## SERVICE LETTER 187

### 10000 ANCHOR CHANNEL INSTALLATION

<b>Aircraft Makes/Model(s):</b>	<b>Float Model(s):</b>	<b>Compliance:</b> Optional	<b>By:</b> RCG
AT-802 AT-802A	10000A	<b>Part Number:</b> 1009888	<b>Approved:</b> JRS
		<b>Date:</b> 9/4/2018	<b>Revision:</b> A

This service letter applies to Air Tractor models AT802 and AT802A with Wipline 10000A Fireboss Amphibious installed per STC SA01795CH

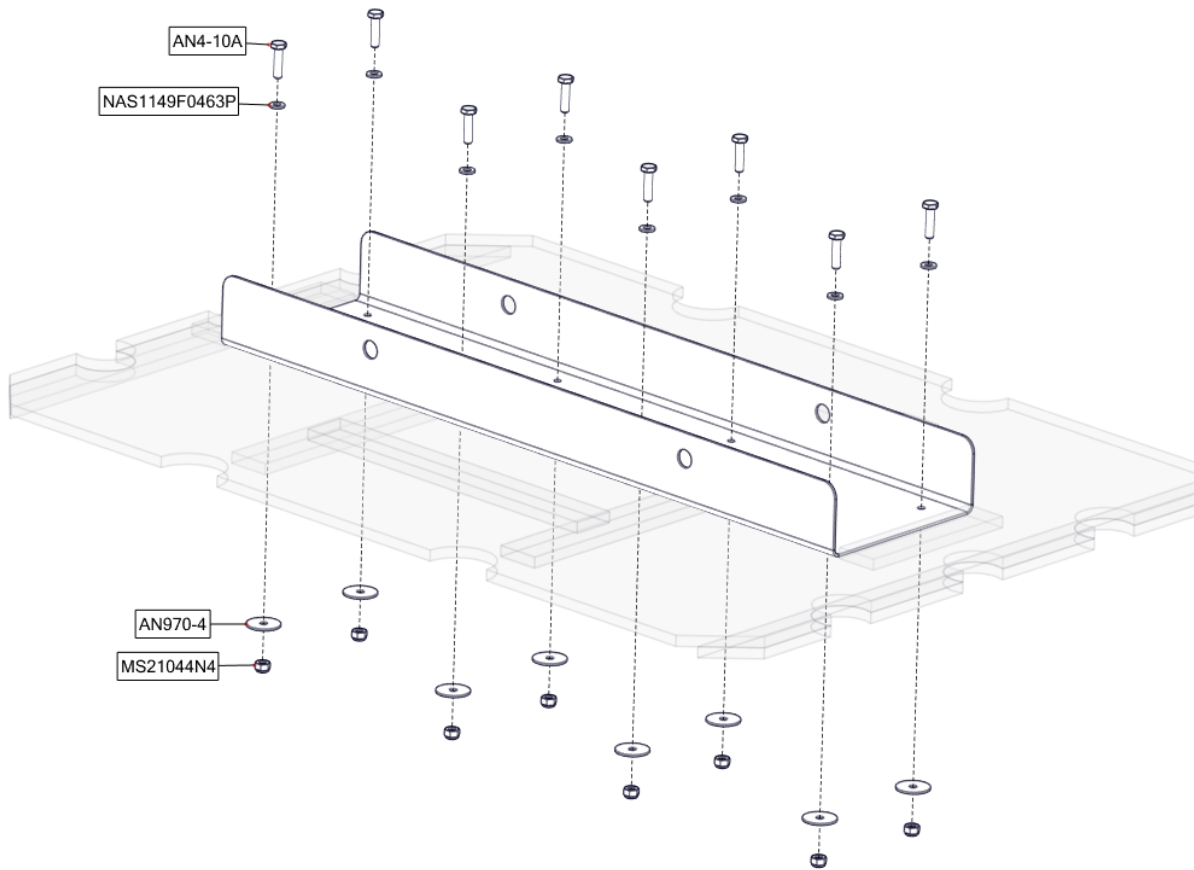
1. Determine which baggage compartment will be used to store anchor and remove foam tank if applicable
2. Open float baggage compartment and center 1009883 anchor channel on baggage floor panel

3. Back drill 1/4" mounting holes into existing baggage floor panel through 1009883 anchor channel and install hardware shown

**NOTE:** Baggage floor panel may be removed if preferred to install 1009883 anchor channel

4. If previously removed, reinstall baggage floor panel with attached 1009883 anchor channel and verify the baggage floor panel is securely attached to the forward and aft bulkheads
5. Use short ratchet straps to secure the anchor in the 1009883 anchor channel
